Docket Item # 3
BAR CASE # 2010-0129

BAR Meeting
November 17, 2010

ISSUE: New Construction
APPLICANT: Urbanvibe Residential LLC by Kulinski Group Architects
LOCATION: 626 North Patrick Street
ZONE: RB/Residential

Figure 5. Front (east) and rear (west) elevations as proposed in *concept review*.

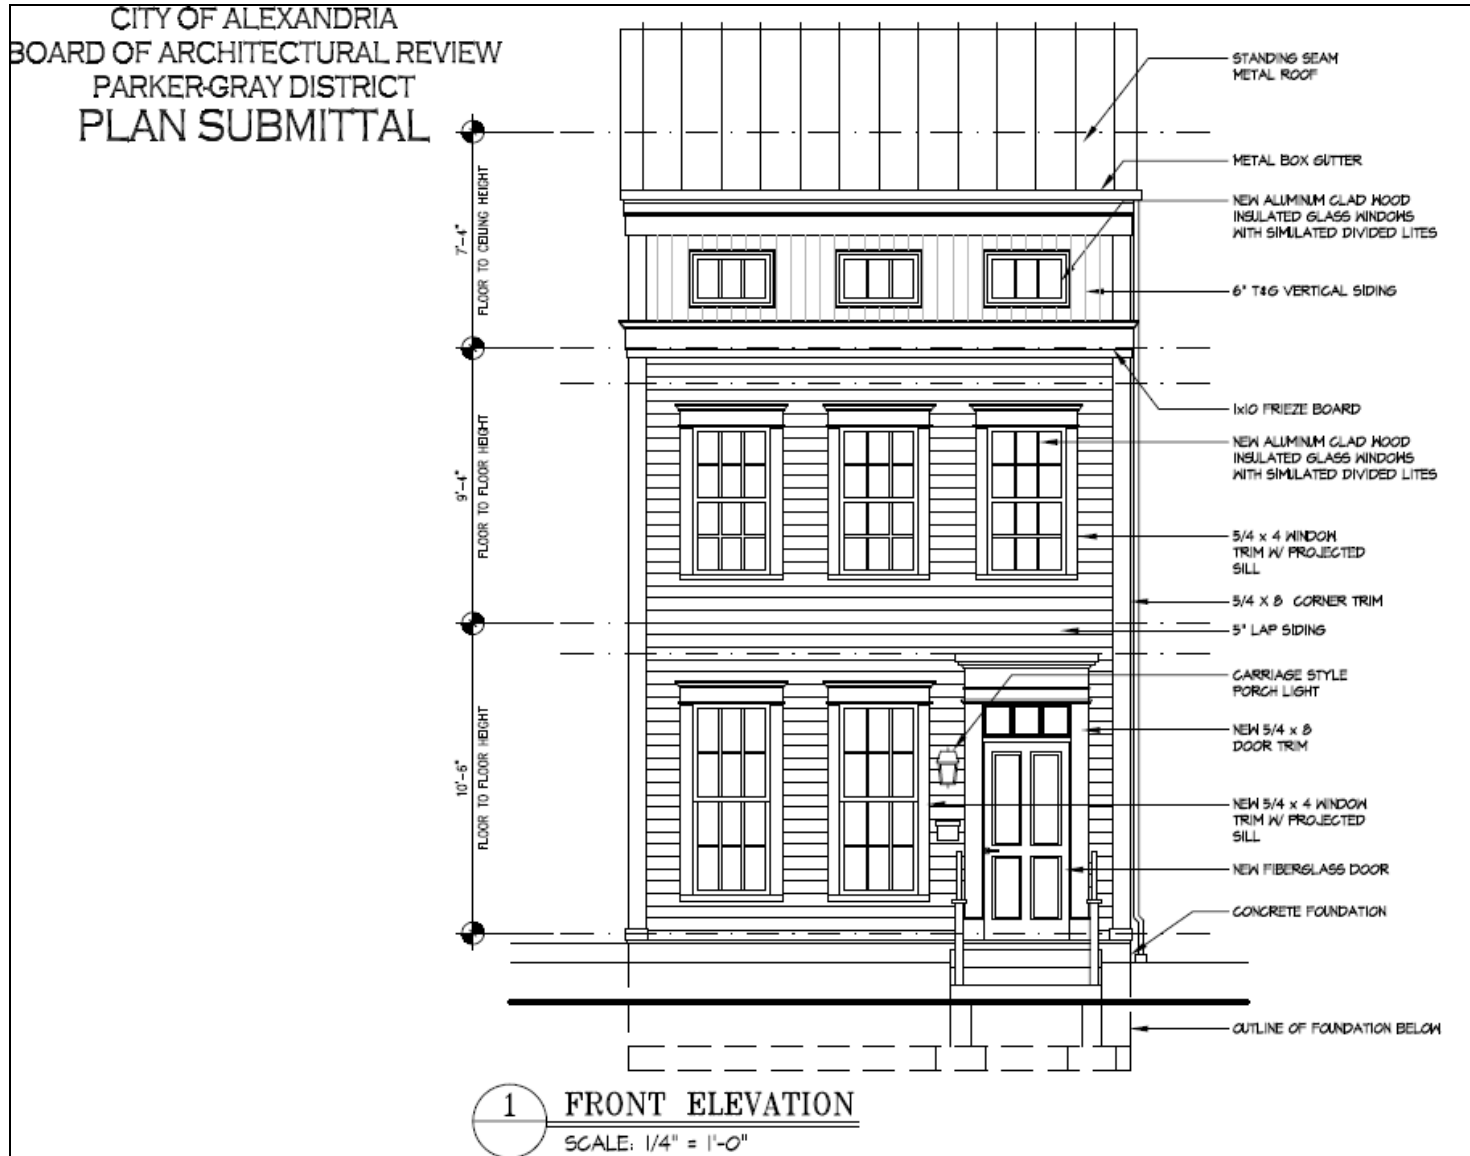
Chairman Conkey asked about the materials in the frieze (butt joint wood) and encouraged a restudy of the proportions of the second floor windows on the rear elevation to give it more compositional interest.

Mr. Duffy moved to approve the concept with the direction to refine the stylistic details and the third floor proportions. Ms. Kelly seconded and the motion passed 6-0.

During the concept review, Staff and the Board recommended that the applicant continue to refine stylistic details. The applicant has made some changes since the concept review, including

the elimination of the first story pedimented window surrounds, the removal of an overscaled cornice on the first story rear doors and the addition of transoms in this location. Staff recommends that a few additional minor adjustments be made. For example, while the window surrounds are appropriate in their strong yet simplified detailing, Staff notes that a more visually pronounced sill will result in a more balanced fenestration.

Figure 6. Proposed front (east) elevation.

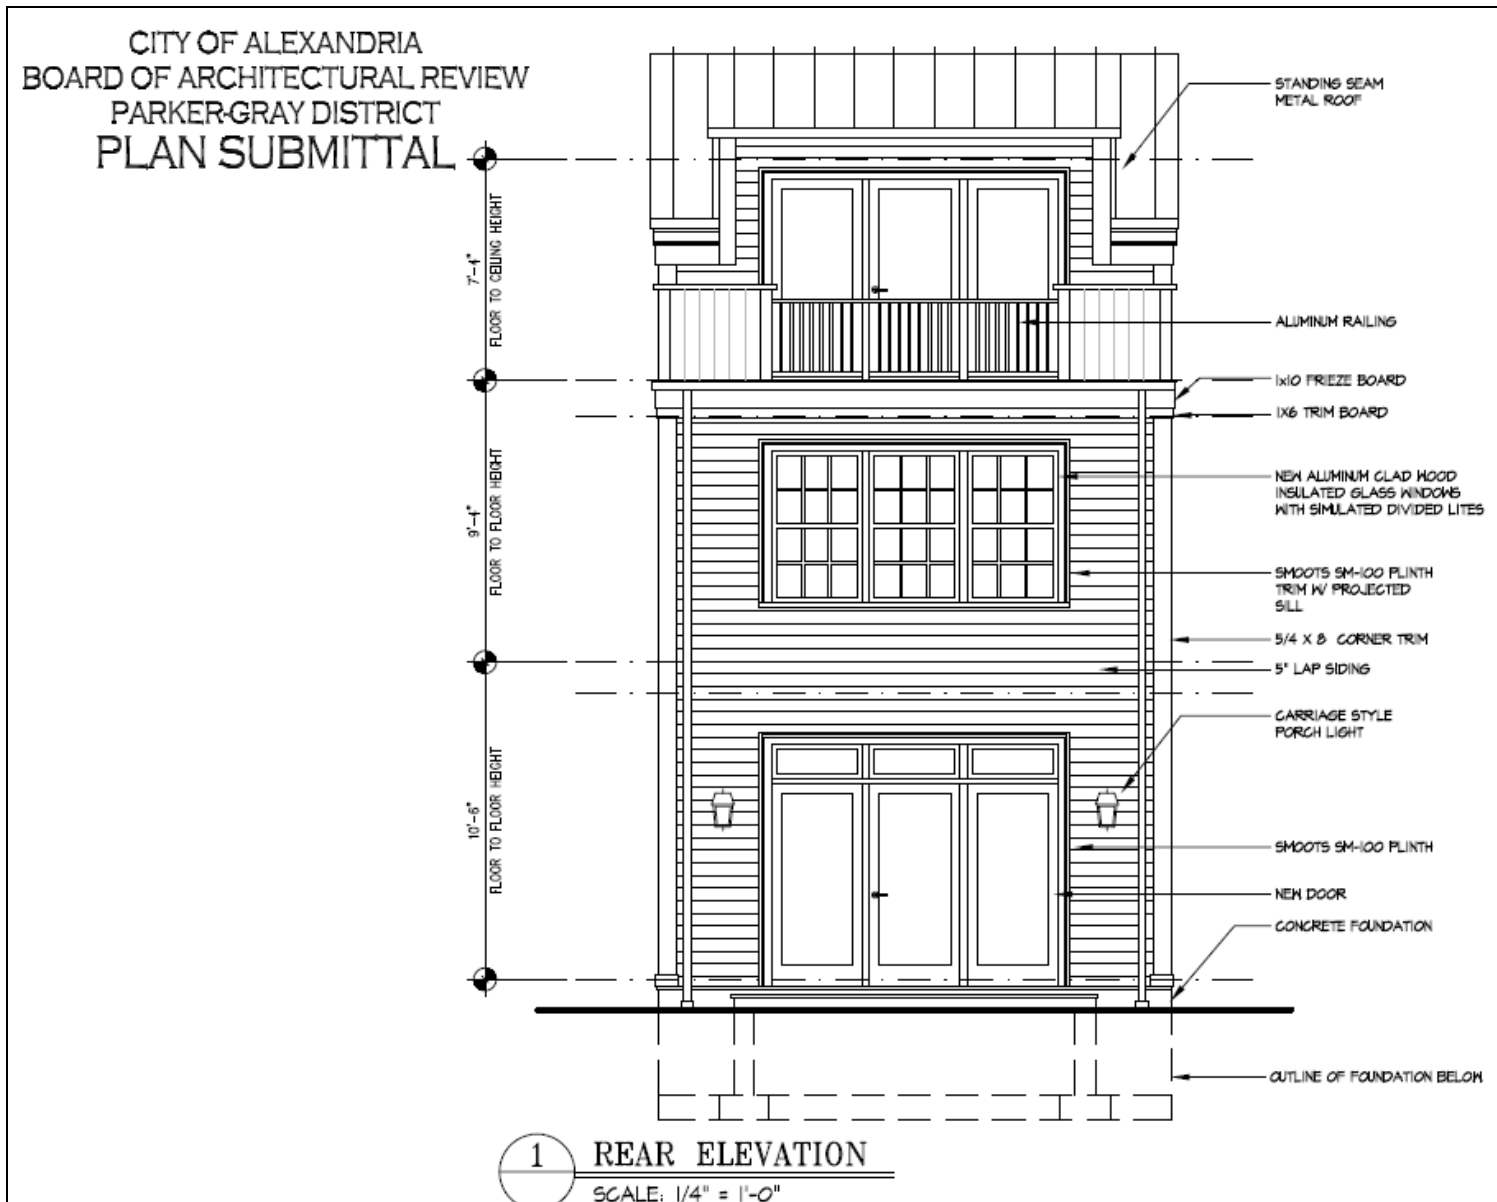
1. That the fiber cement siding be smooth and that the nails not show in the installation.
2. That the window sills on the front elevation be made more prominent.

Figure 7. Proposed rear (west) elevation.

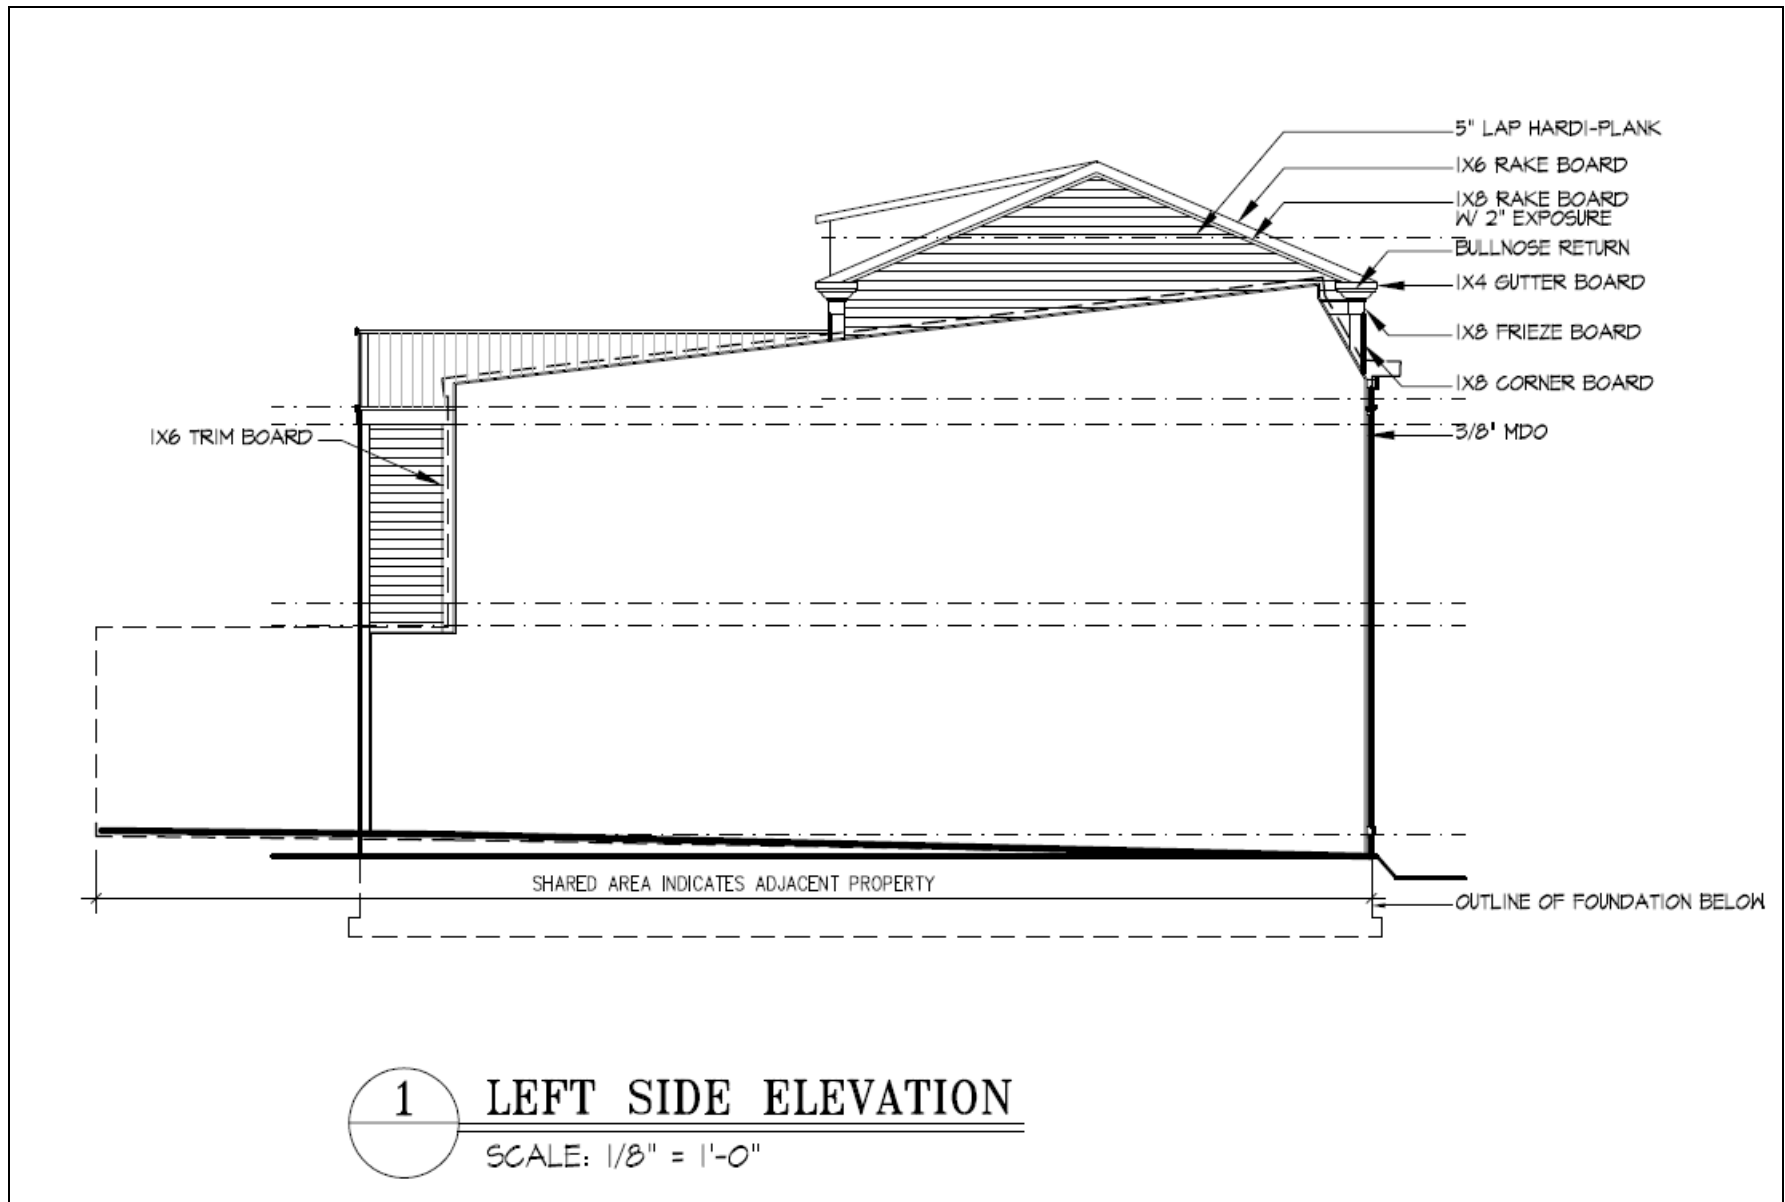
3. That the applicant submit specifications for the railings on the front stoop and rear deck.
4. That the doors on the rear elevation be multi-light to be consistent with the rear elevation windows and overall architectural detailing.
